No. 1243  
ATA Code 71-00

**SUBJECT:** POWER PLANT - INSTALLATION OF WASHERS ON ENGINE CONTROL ROD ENDS

## Service Instructions No. 1243

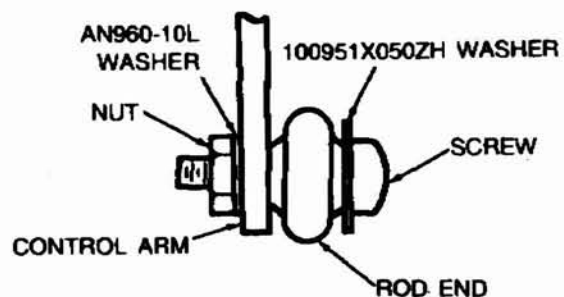
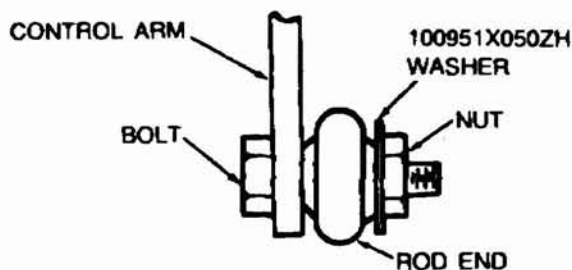
1. Gain access to the engine compartment and disconnect the throttle, mixture, carburetor heat (if applicable) and/or propeller governor (if applicable) control cables which have rod ends installed. Inspect the rod ends for condition and replace as necessary.

2. Remove the AN960-10 washer, if installed, and, using either illustration as a guide, install the rod end connecting hardware. Note that the bolt may be installed from either side of the control arm.

Some installations may require the bolt/screw to be replaced with the next longer size.

Check installation to make certain that there is no interference between the rod end bolt/nut and other components.
